**TOWN OF NEWBURGH
PLANNING BOARD
TECHNICAL REVIEW COMMENTS**

PROJECT: THE RIDGE (f/k/a THE LOOP)
PROJECT NO.: 17-01
PROJECT LOCATION: RT.300 & RT.52 SECTION, BLOCK & LOT: MULTIPLE
REVIEW DATE: 27 APRIL 2017
MEETING DATE: 4 MAY 2017
PROJECT REPRESENTATIVE: DIVNEY TUNG SCHWALBE, LLP

Re: The Hudson Valley Ridge (f/k/a The Loop)
Response to Orange County Dept. of Planning Comments
Project No. 17-01

Road F / Gravel Maintenance Path To Existing San. Sewer Manhole And Brookside Ave.

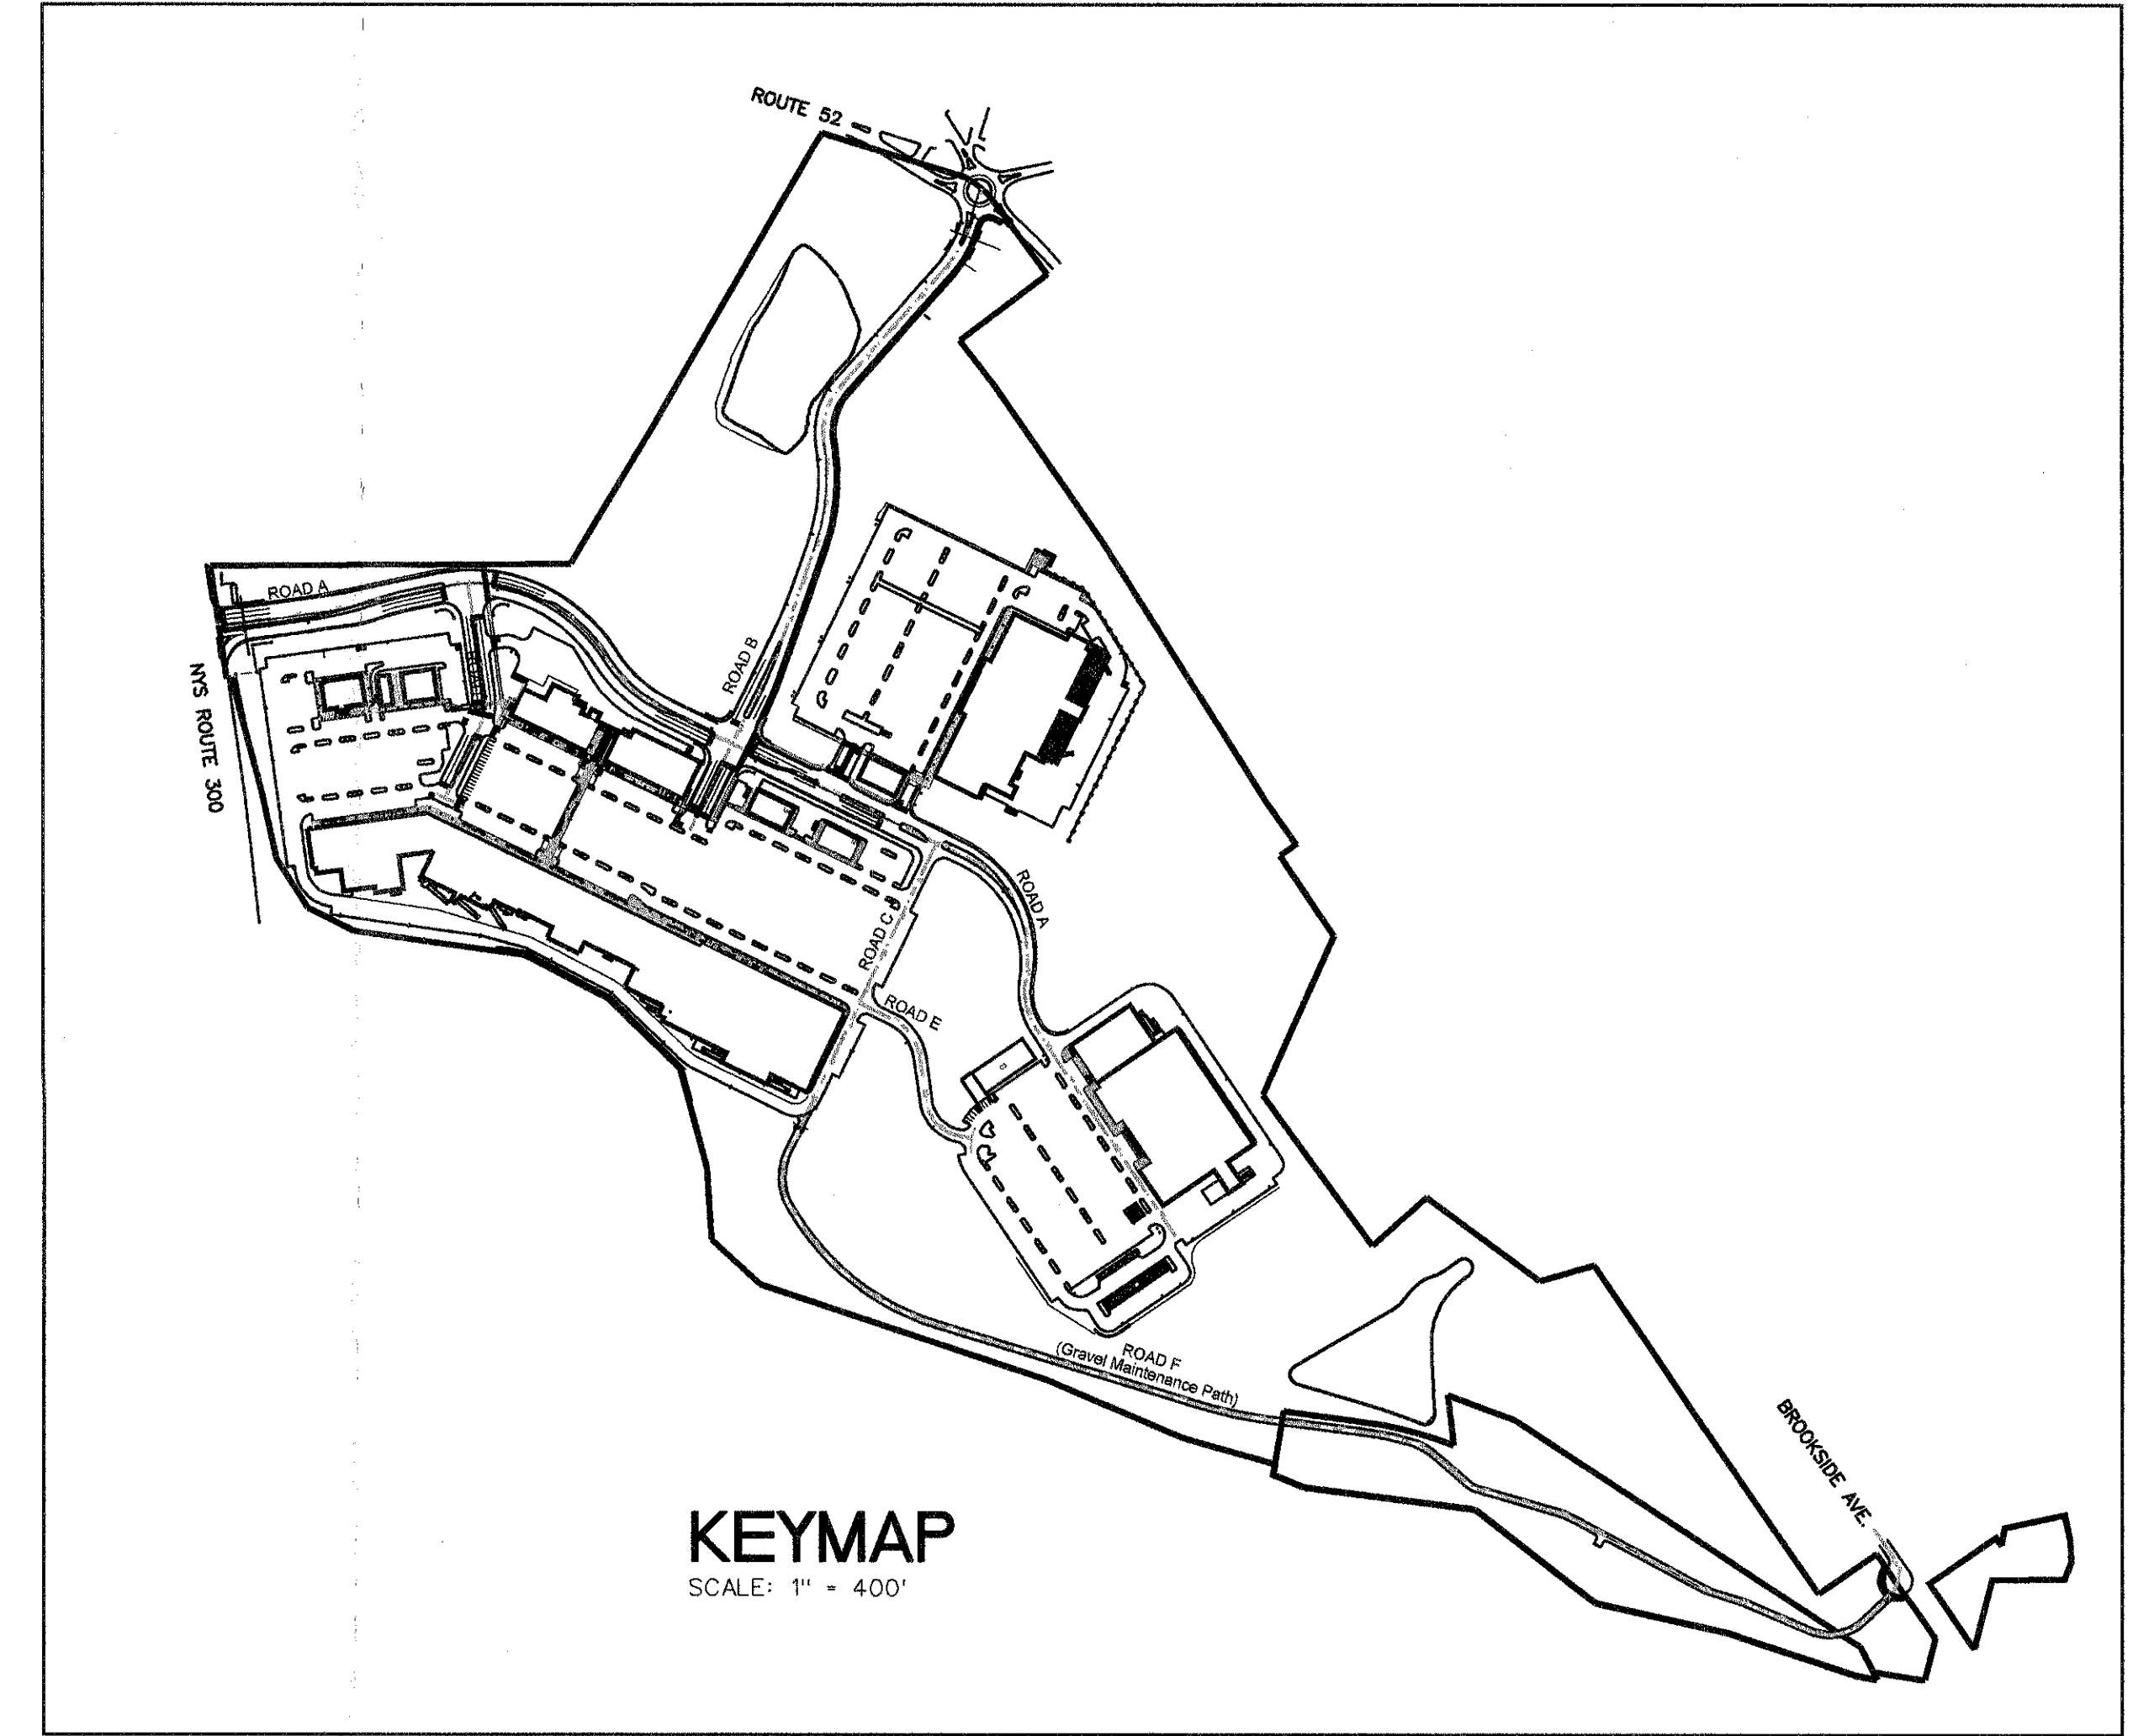
5. A gravel maintenance path has been labeled on the plans. This should be labeled as Emergency Access Drive to specifically delineate the area for Emergency Vehicle access to the site. Revised findings should address long term maintenance of the Emergency Access Drive during all weather conditions.

1. **Extension of the Road F/Gravel Maintenance Path** (Refer to attached Drawings SP-1.0, 1.3, 1.5, 1.7, 1.8, 2.3 and 3.0, last revised 4/4/17.)
